Agenda Item: **RZ12-006 8610 Roswell Road**, a request to rezone the subject property from CUP (Community Unit Plan District) conditional C-2 (Commercial District) to allow an Automotive Garage.

Rezoning Petition No. RZ12-006/CV12-007

TO REZONE A PROPOSED OUTPARCEL (THE SUBJECT PROPERTY) FROM CUP (COMMUNITY UNIT PLAN DISTRICT) CONDITIONAL TO C-2 (COMMERCIAL DISTRICT), WITH CONCURRENT VARIANCES

DATE	03/27/12
PROJECT NO.	12401
DRAWN BY	MOR
SCALE	1"=20'
DRAWING TITLE	SITE PLAN (REZONING EXHIBIT)

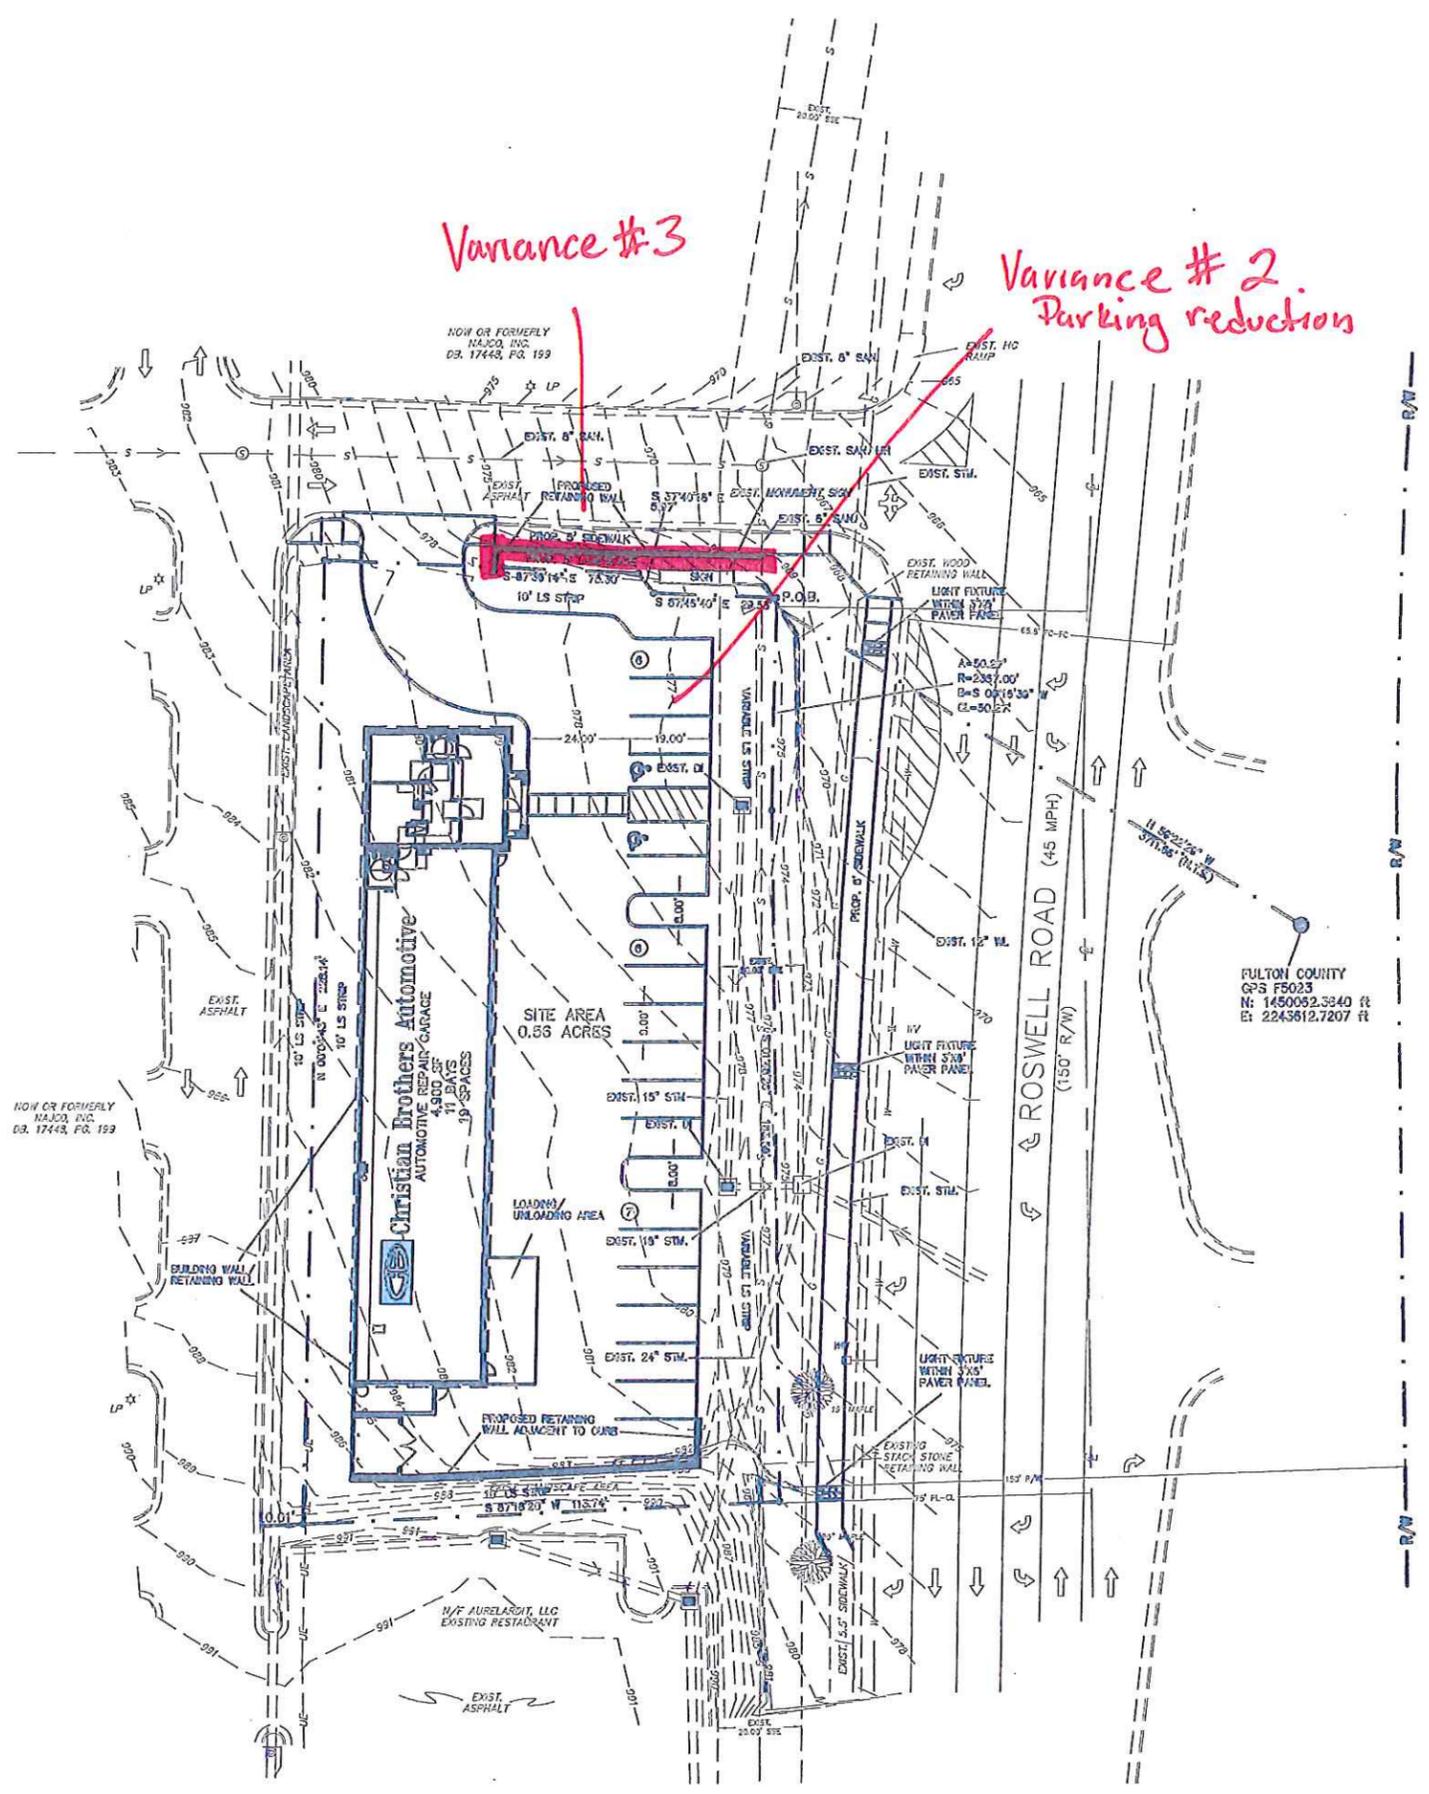
The site plan submitted shows the proposed outparcel and the proposed 4,900 square foot Automotive Garage. The Automotive Garage is shown on the western side of the property. The site plan shows the entrance to the property on the northwest corner coming off the existing driveway of the Shopping Center. The property slopes from an elevation of 990 on the southwest corner to an elevation of 970 on the northeast corner.

The applicant is requesting a variance to reduce the required twenty-five (25) spaces to nineteen (19) spaces.

1. Variance from the Tree Conservation Ordinance, Administrative Standards, & Best Management Practices - Landscape Strips, Buffers, and Parking (F.1) to relieve the requirement of planting a large shade tree every 6 parking spaces for all new parking lots- **ADMINISTRATIVELY WITHDRAWN**
2. Variance from Section 18.2.1. of the Zoning Ordinance to reduce the required off-street parking for an Automotive Garage from twenty-five (25) spaces to nineteen (19) spaces.

*The applicant has a shared parking agreement with the adjacent Shopping Center to handle any potential overflow of parking. The staff is of the opinion the variance request is in harmony with the intent of the Zoning Ordinance and the proposal will not pose a detriment to the public. Therefore, based on these reasons, the staff recommends **APPROVAL** of the variance to reduce the required twenty-five (25) parking spaces to nineteen (19).*

1. To the owner's agreement to abide by the following:
 - a. To the site plans received by the Department of Community Development on April 4, 2012. Said site plan is conceptual only and must meet or exceed the requirements of the Zoning Ordinance and these conditions prior to the approval of a Land Disturbance Permit. In the event the Recommended Conditions of Zoning cause the approved site plan to be substantially different, the applicant shall be required to complete the concept review procedure prior to application for a Land Disturbance Permit. Unless otherwise noted herein, compliance with all conditions shall be in place prior to the issuance of the first Certificate of Occupancy.

2. Variance from Section 18.2.1. of the Zoning Ordinance to reduce the required off-street parking for an from twenty-five (25) spaces to nineteen (19) spaces (CV12-007)

DATE: 03/29/2012
PROJECT NO: 11462
DRAWN BY: LPS / KAH
SCALE: 1"=20'
DRAWING TITLE: CONCEPTUAL LANDSCAPE PLAN
L1.01

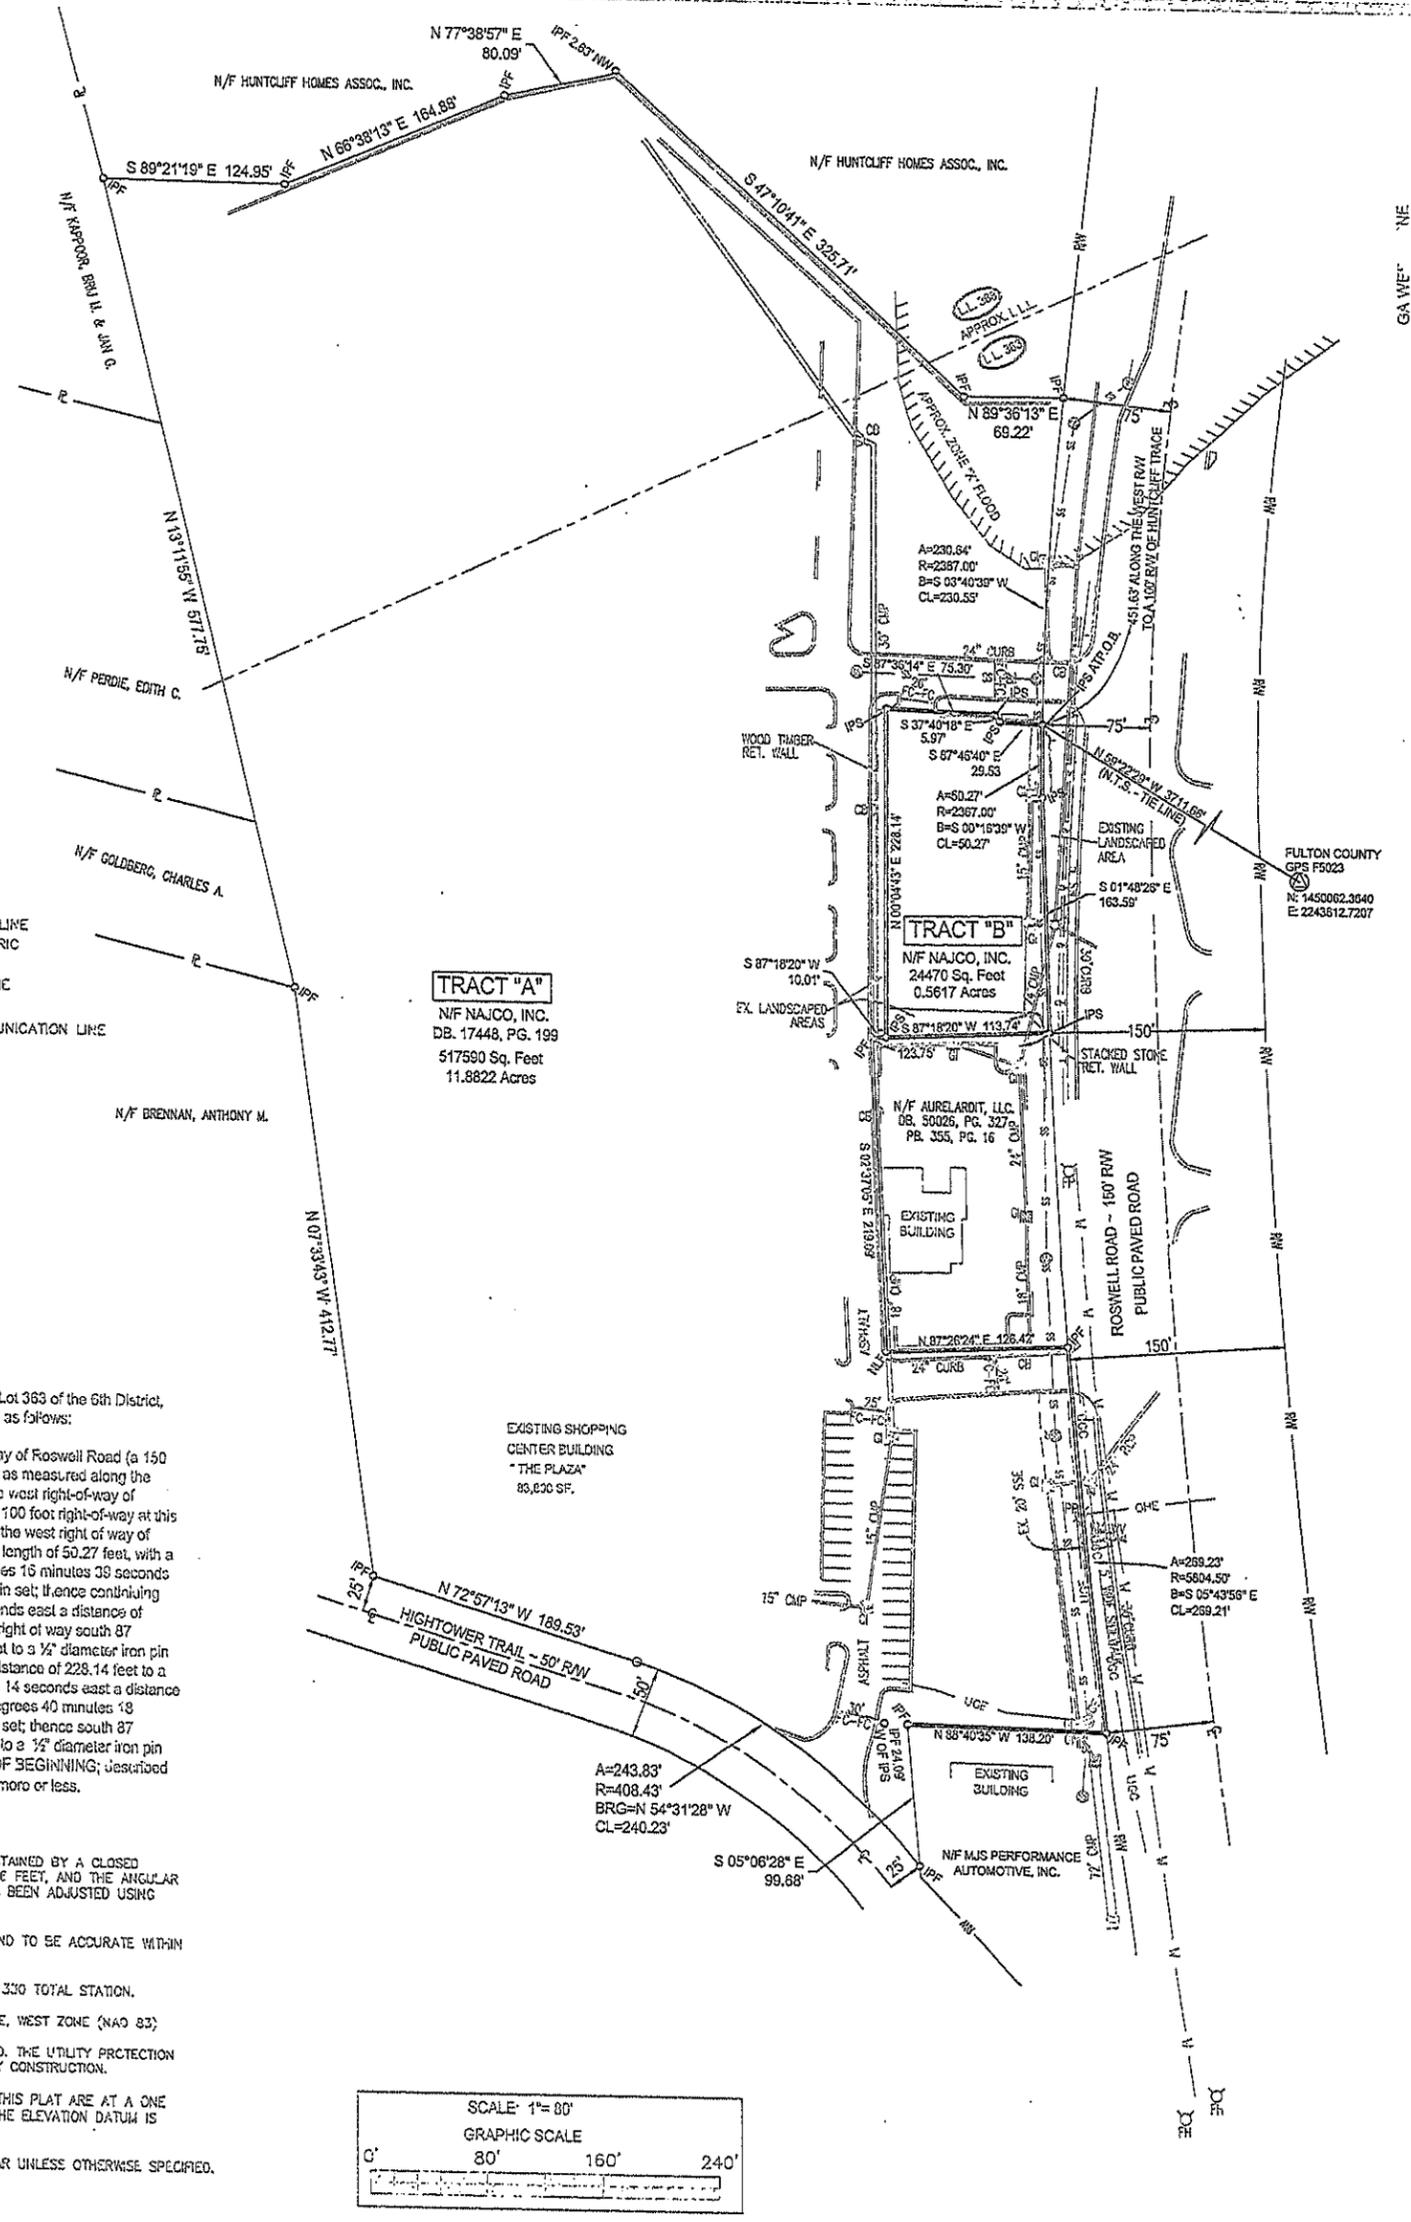
The applicant is requesting variance from Section 4.23.1. of the Zoning Ordinance to allow a retaining wall within a required ten (10) foot landscape strip along the proposed northern property line. The variance request for the Tree Conservation Ordinance, Administrative Standards, & Best Management Practices - Landscape Strips, Buffers, and Parking (F.1) to relieve the requirement of planting a large shade tree every 6 parking spaces for all new parking lots was administratively withdrawn due to the change of the Zoning Ordinances at the May 15, 2012 Mayor and City Council meeting. The applicant is proposing to screen the parking lot from Roswell Road by installing a continuous evergreen screen and proposing to meet the streetscape standards of the Suburban Overlay District.

3. Variance from Section 4.23.1. of the Zoning Ordinance to allow a retaining wall within a required ten (10) foot landscape strip along the proposed north property line.

The proposed retaining wall, though considered an impervious, man-made surface, is also considered open space that would promote pedestrian activity by creating the an area to install a five (5) foot sidewalk onto the subject property. The proposed sidewalk satisfies the Overlay District's regulation that intra-parcel walkways are required. The staff is of the opinion the variance request is in harmony with the intent of the Zoning Ordinance

and the proposal will not pose a detriment to the public. Therefore, based on these reasons, the staff recommends APPROVAL of the variance to allow a retaining wall within a required ten (10) foot landscape strip along the proposed southern property line.

3. Variance from Section 4.23.1 of the Zoning Ordinance to allow a retaining wall(s) within the required ten (10) foot landscape strip(s).
